SIBLING  
ARCHITECTURE

OLD BEGA HOSPITAL  
ARTS & CULTURAL CENTRE

CONCEPT DESIGN REVIEW 06  
26.02.2018

PREVIOUS PLAN SHOWING NORTH WEST ENTRY

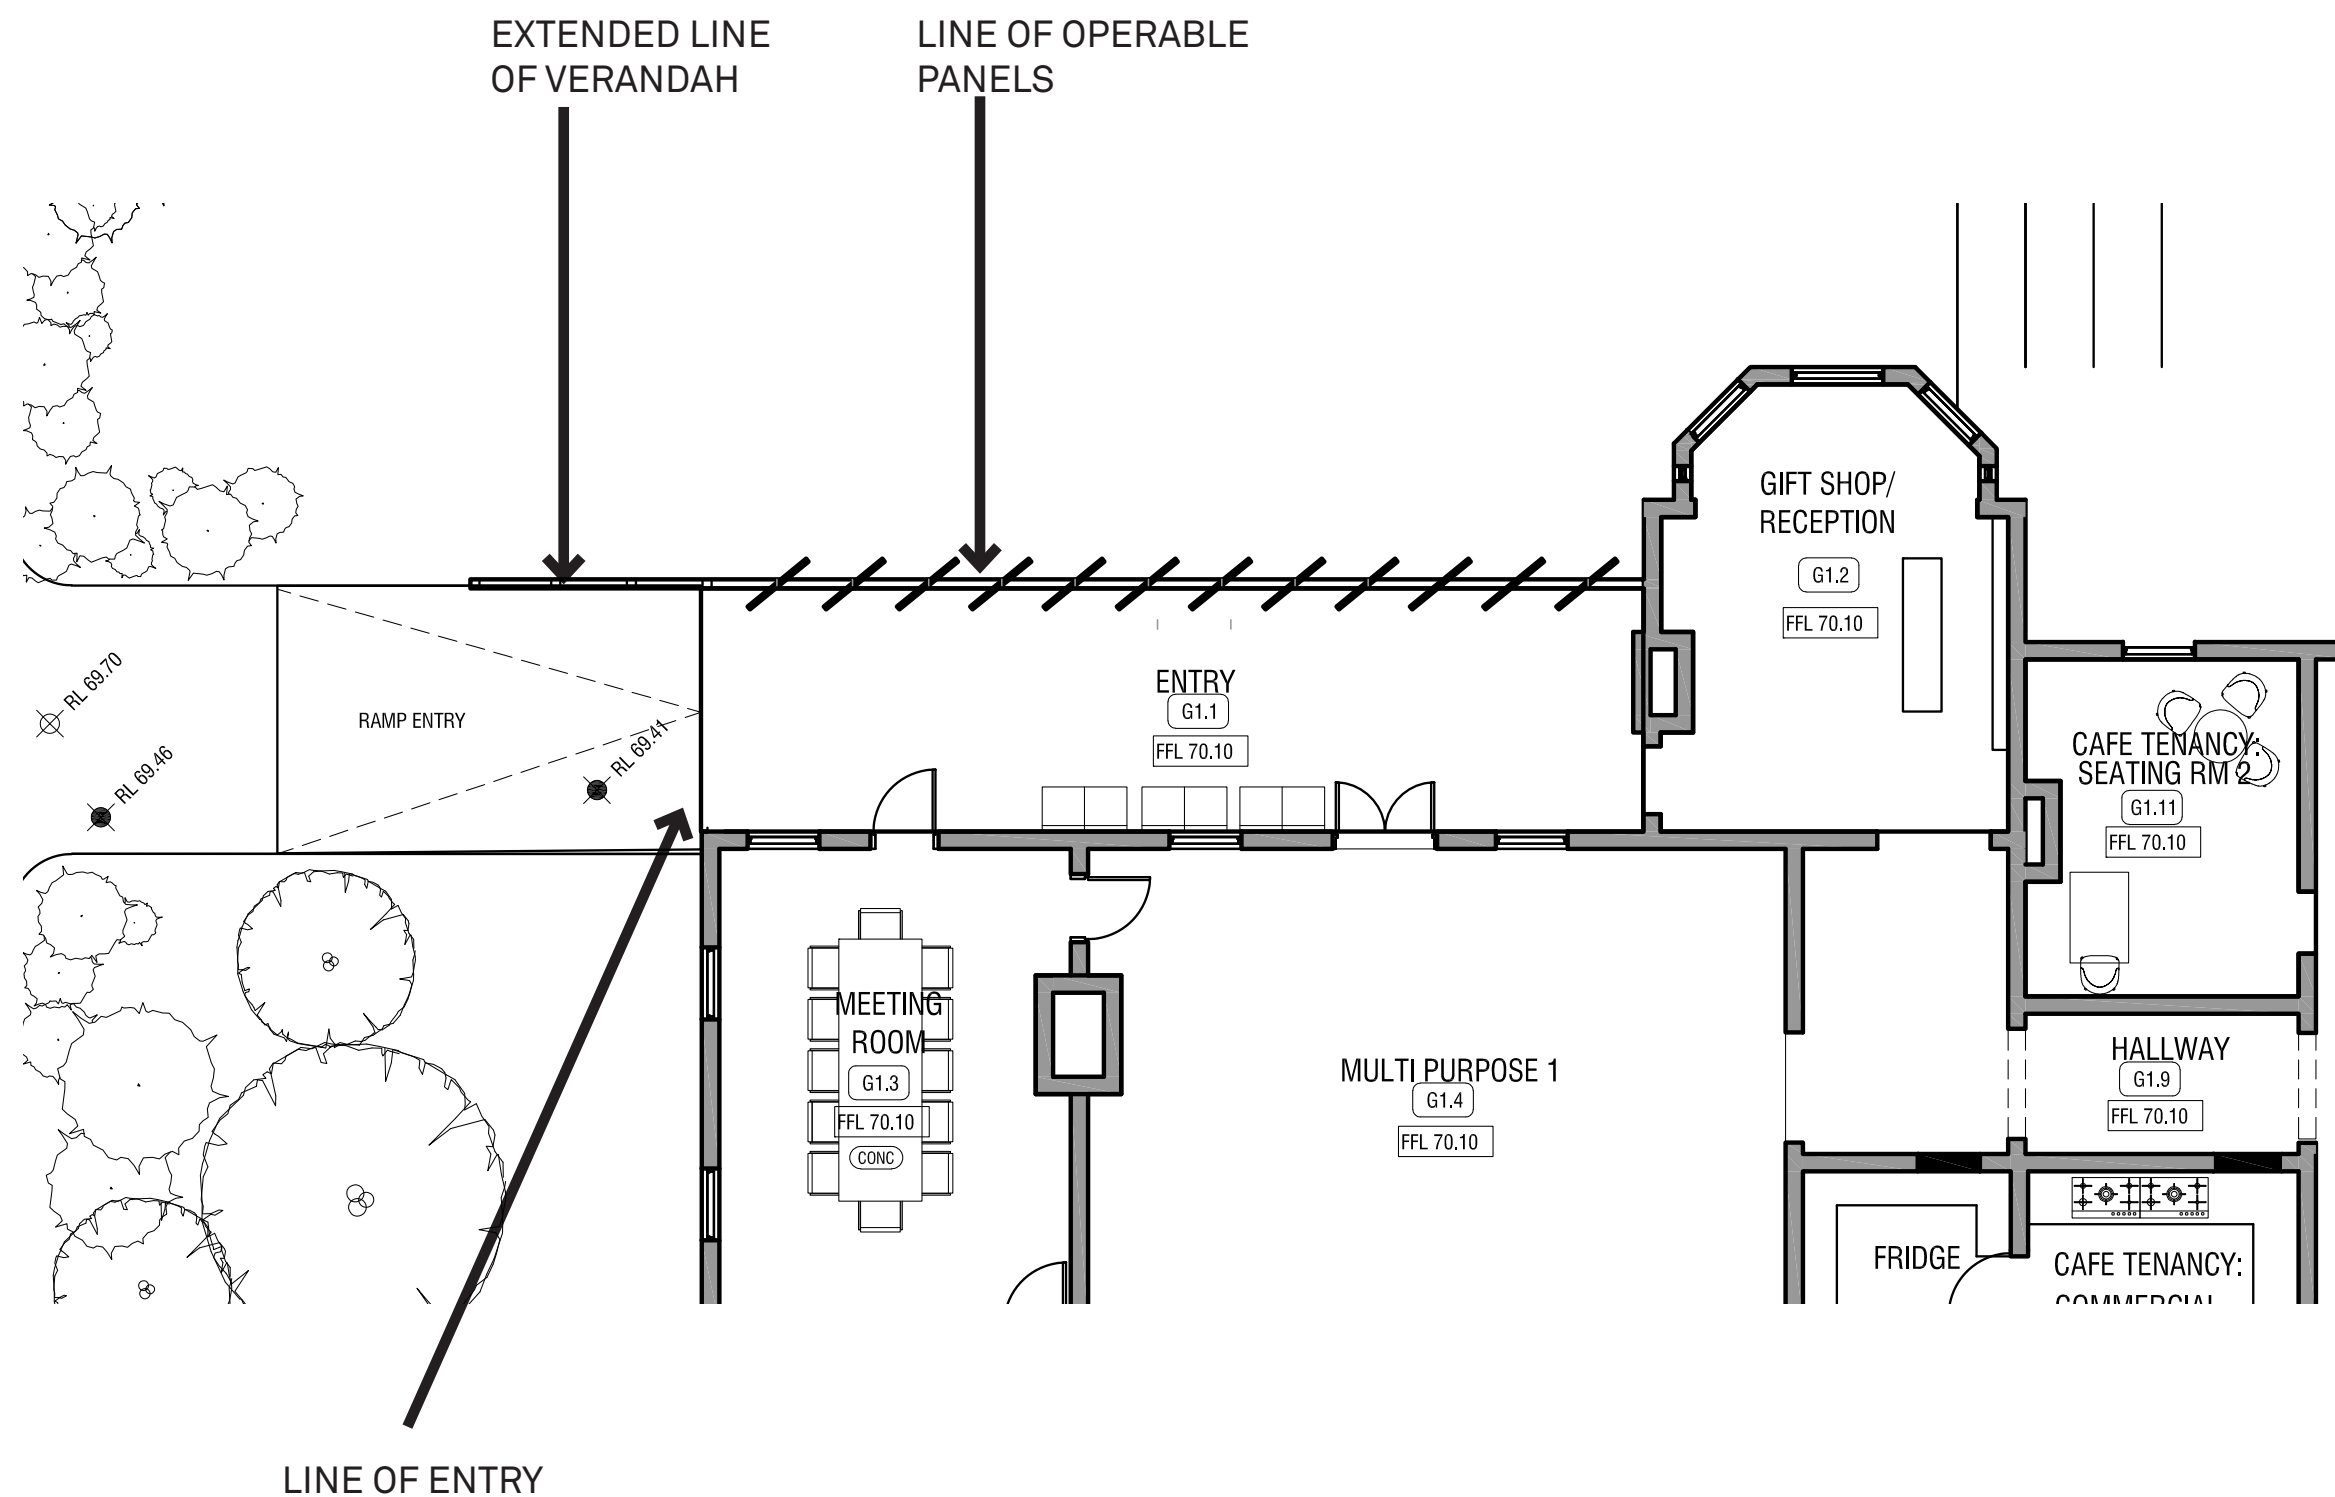
- 1) THE ENTRY TRANSITION SHOULD BE BROUGHT WITHIN THE EXISTING BUILDING LINE.
- 2) CONFIRMED THE USE OF GLAZING TO OPERABLE PANELS. THE LINE OF PANELS TO BE INSET FROM EAVE LINE.
- 3) ENTRY LINE TO BE BROUGHT WITHIN ROOF LINE TO ALLOW FOR PROTECTION FROM RAIN

PLAN SHOWING CHANGES TO NORTH WEST ENTRY

**PREVIOUS PLAN SHOWING SOUTHERN ENTRY**

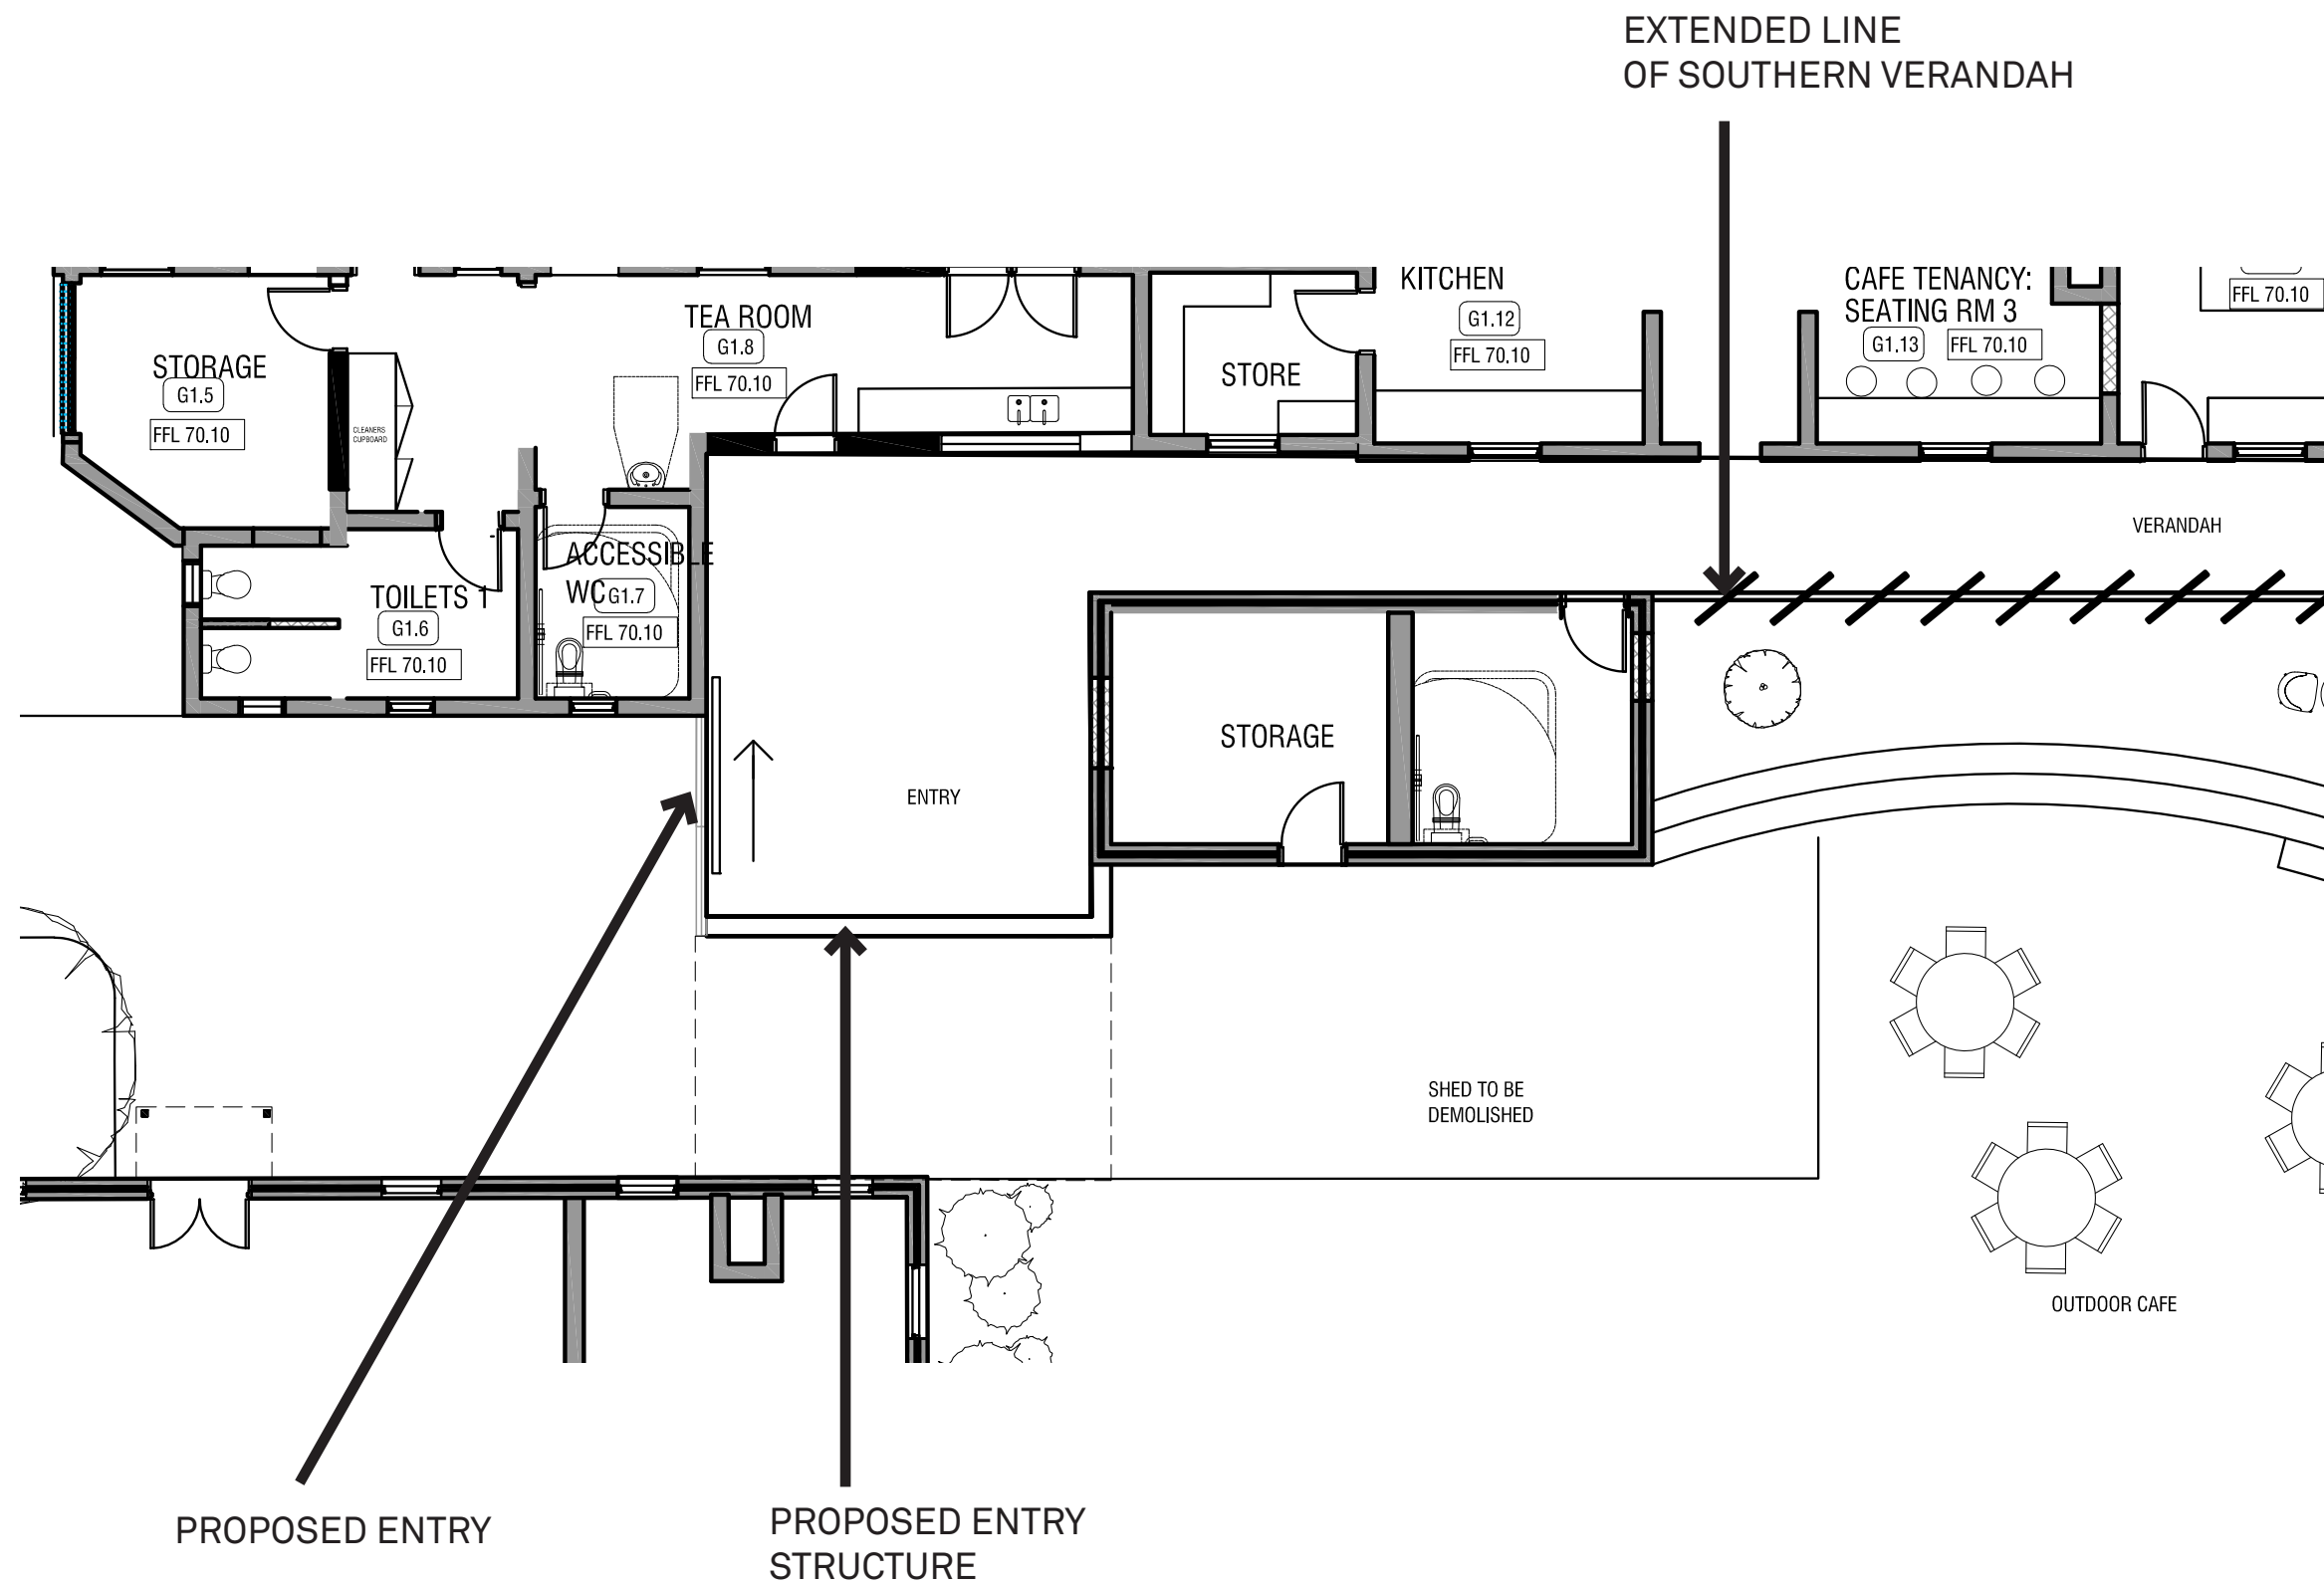
- 1) NO STRUCTURE TO SOUTHERN ENTRY AS SUCH
- 2) EXTENTION TO THE SOUTHERN VERANDAH AND NECESSARY MODIFICATIONS
- 3) RETAIN CONTINOUS ACCESS ALONG THE SOUTHERN SIDE AND TO INCLUDE ENTRIES TO EITHER SIDE OF THE MORGUE

**PLAN SHOWING CHANGES TO SOUTHERN ENTRY**

**PLAN SHOWING CHANGES TEA ROOM**

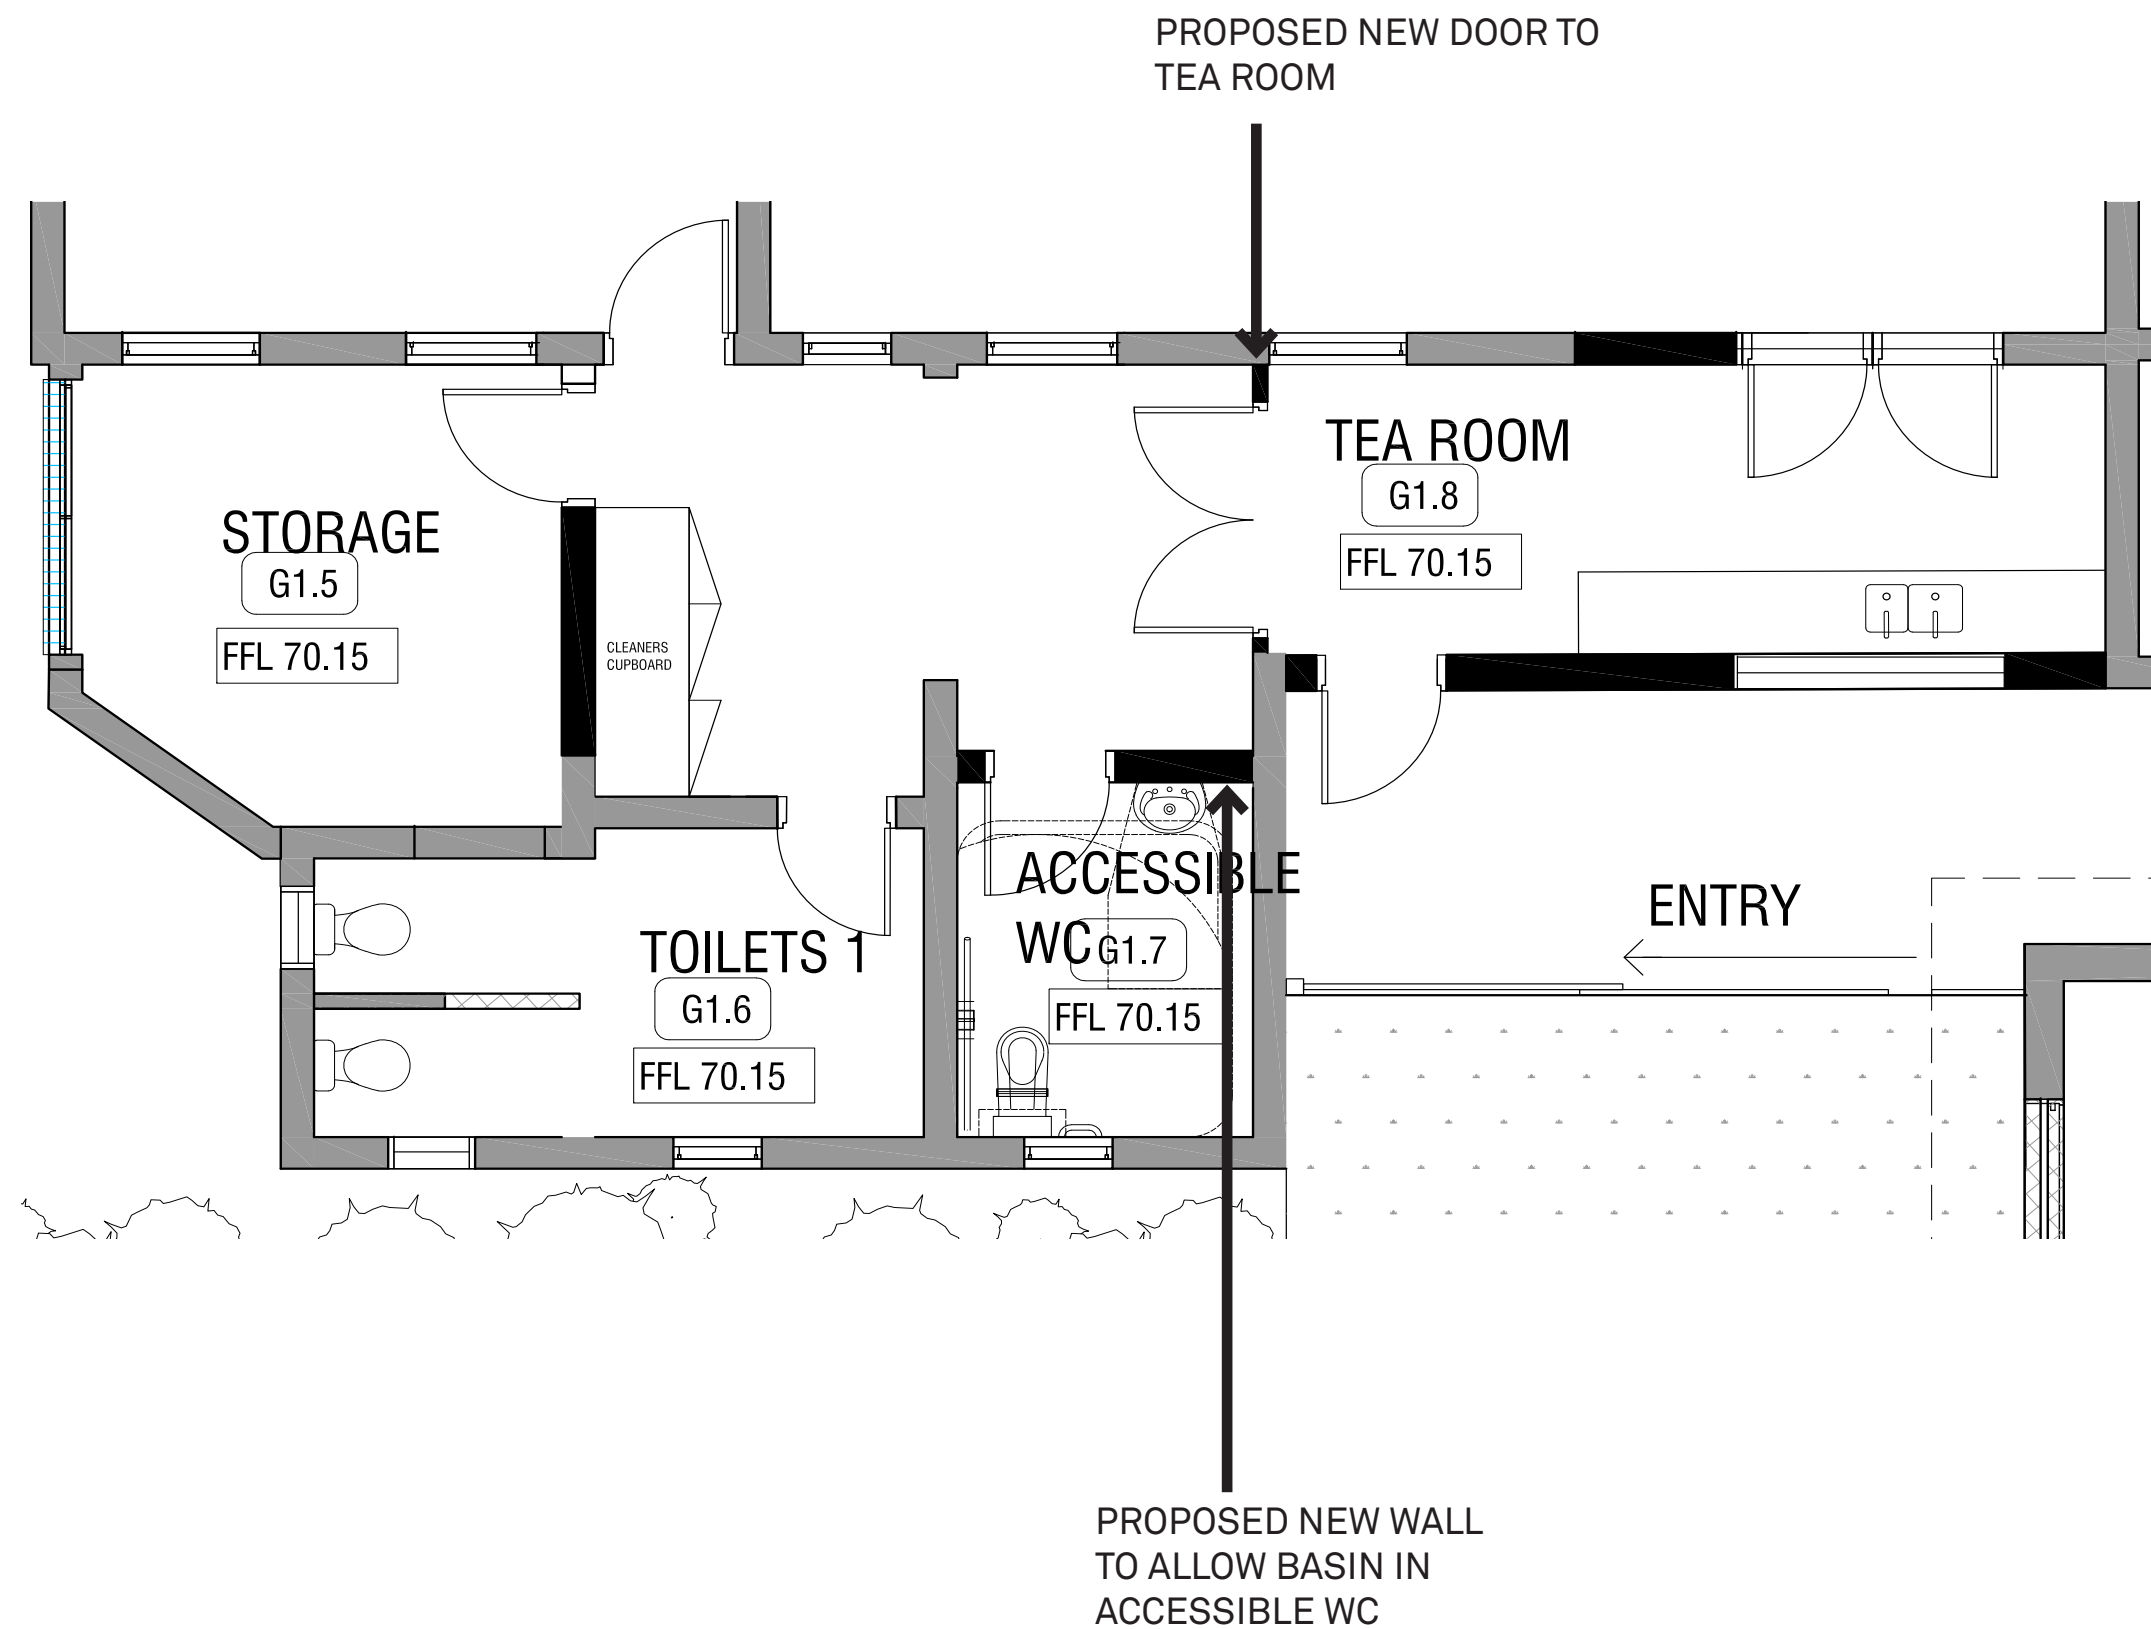
- 1) MOVE EXISTING DISABLED TOILET NORTH TO ALLOW BASIN INSIDE
- 2) SEPARATE ENTRY TO DISABLED TOILET FROM TEAROOM
